ADDENDUM NO. 1

**Annual Street Resurfacing & Preventative Maintenance
Project No. 25503**

ANNUAL STREETS RESURFACING AND PREVENTATIVE MAINTENANCE PROJECT - CIP NO. 25503
APRIL 2025

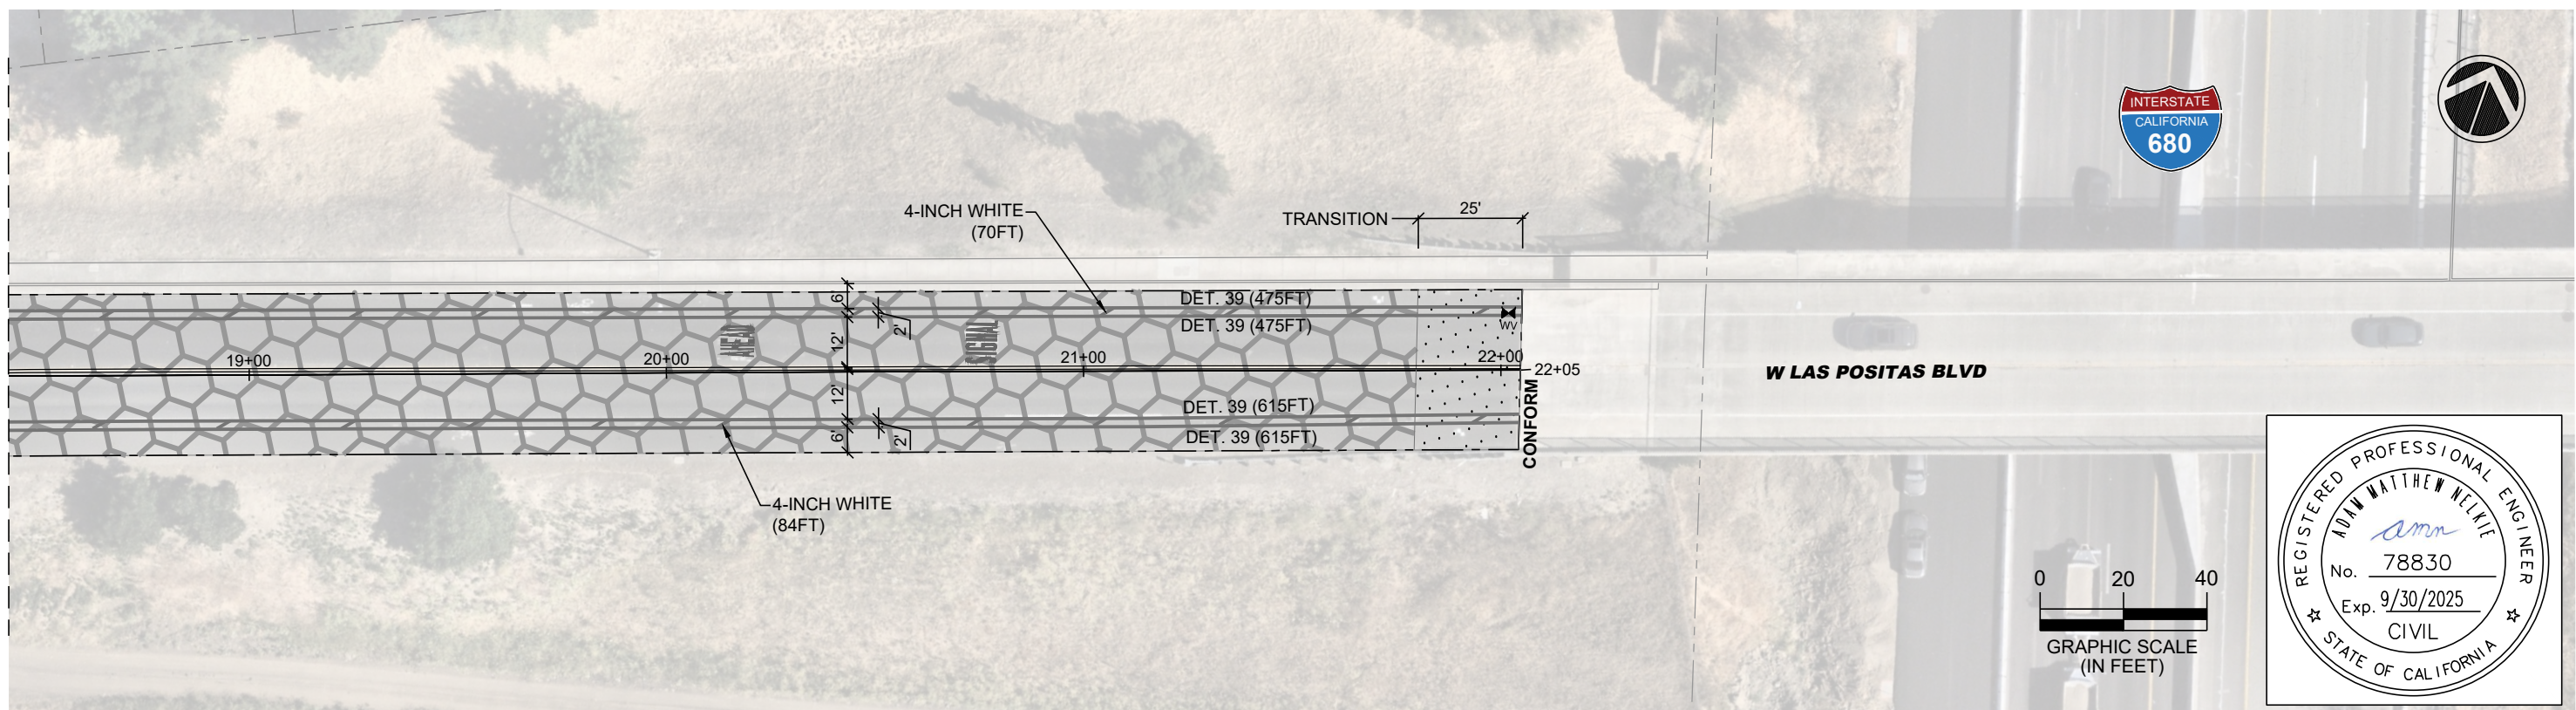
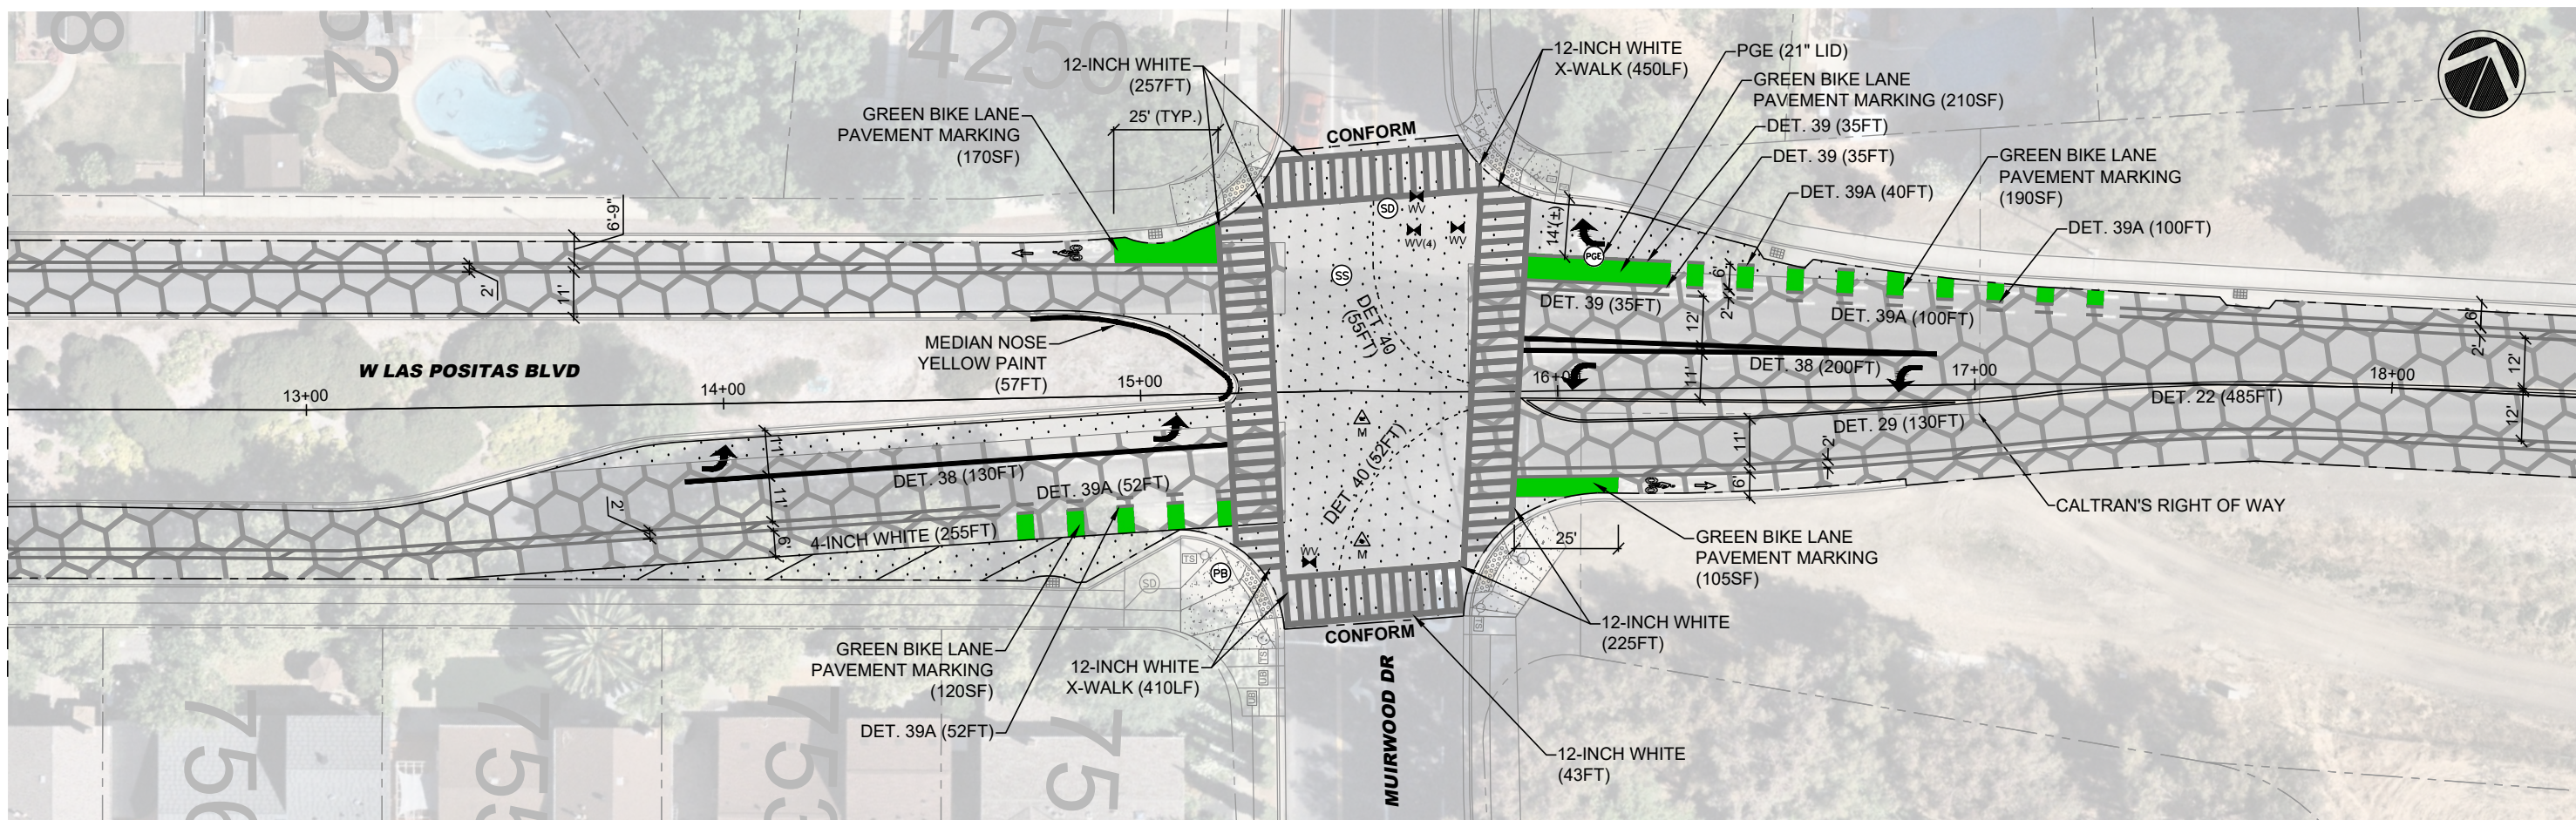
- 11) Replace plan sheet DWG No. A1-1 (ALT. A) and DWG No. A1-2 (ALT. A) with A1-1R (ALT. A) and A1-2R (ALT.A) for striping changes.
- 12) Replace plan sheet DWG No. A1-1 (ALT. B) and DWG No. A1-2 (ALT. B) with A1-1R (ALT. B) and A1-2R (ALT.B) for striping changes and to correct hatching called-out (HMA Overlay with Fabric instead of mill/cold plane & overlay).
- 13) Replace plan sheet DWG No. A6-1 (ALT. B) with DWG No. A6-1R (ALT. B) to correct text called-out “2” HMA OL with Paving Mat” instead of “4” CIR/2” OL.”
- 14) Replace second and third paragraphs of Section 23-01K, West Las Positas Widening, page 75, of the Project’s Special Provisions with

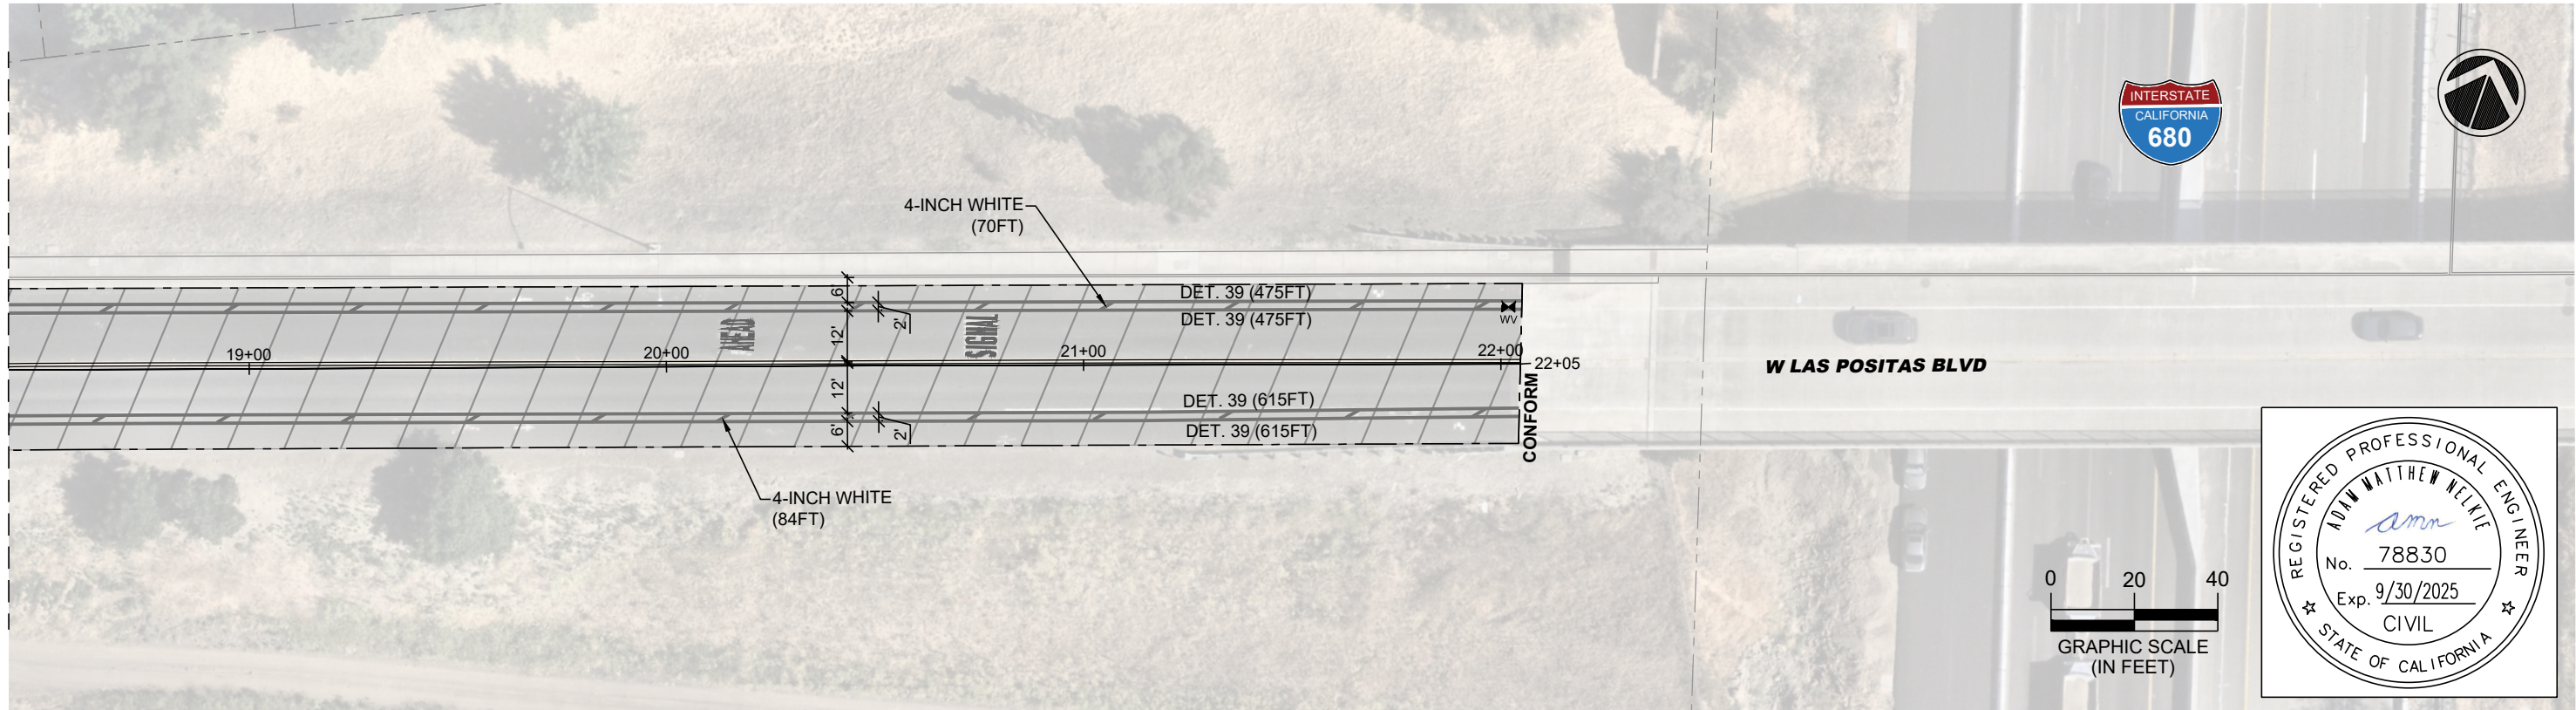
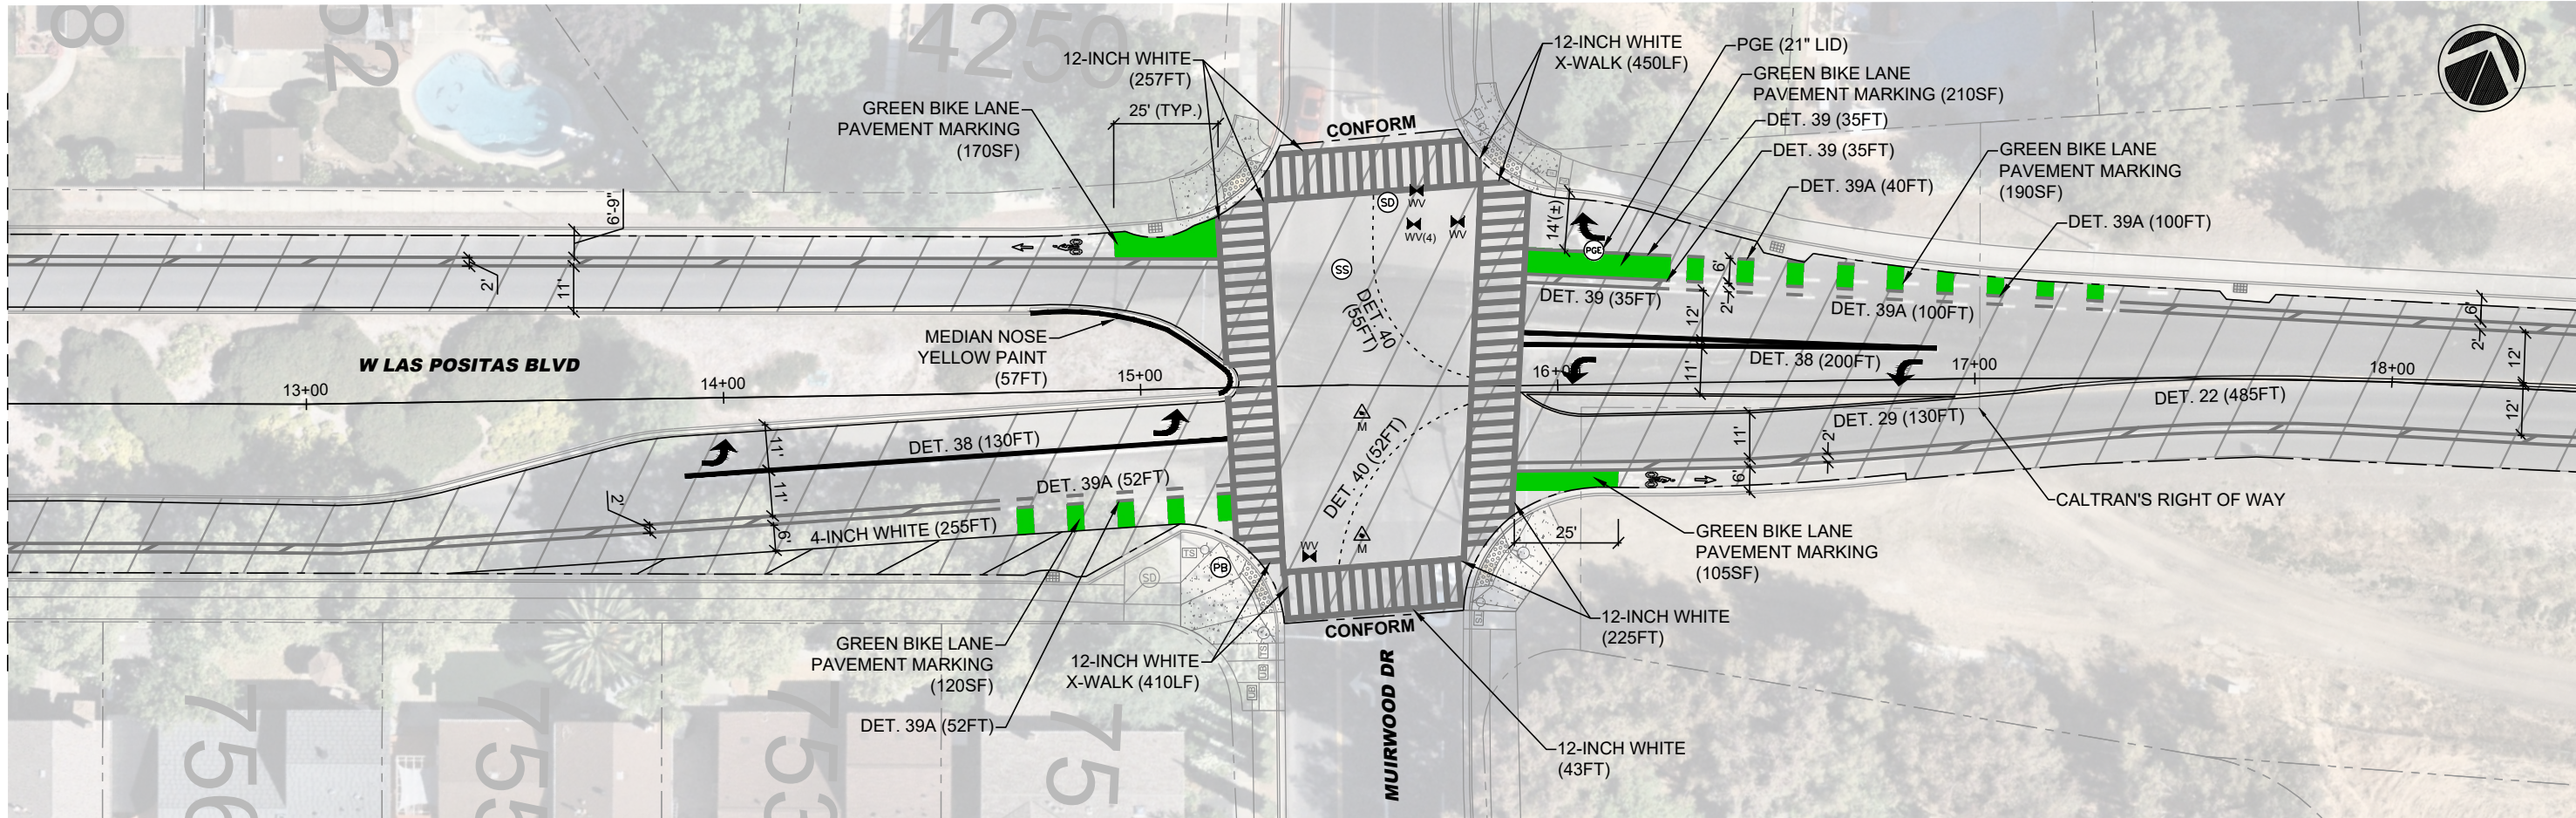
- h) On W. Las Positas Blvd. for Bid Alternative B, plan sheets 10 & 12, the streets resurfacing is hatched as Mill/Cold-Plane and Overlay, but in the Construction Details on plan sheet 8 show the proposed surface as just 2" HMA Overlay with a 6' wedge cut. Please clarify which operation is being done on this street and correct the plan sheets.

- Treatment for W. Las Positas, Alt. B is HMA overlay with Fabric. See Item #12 above.
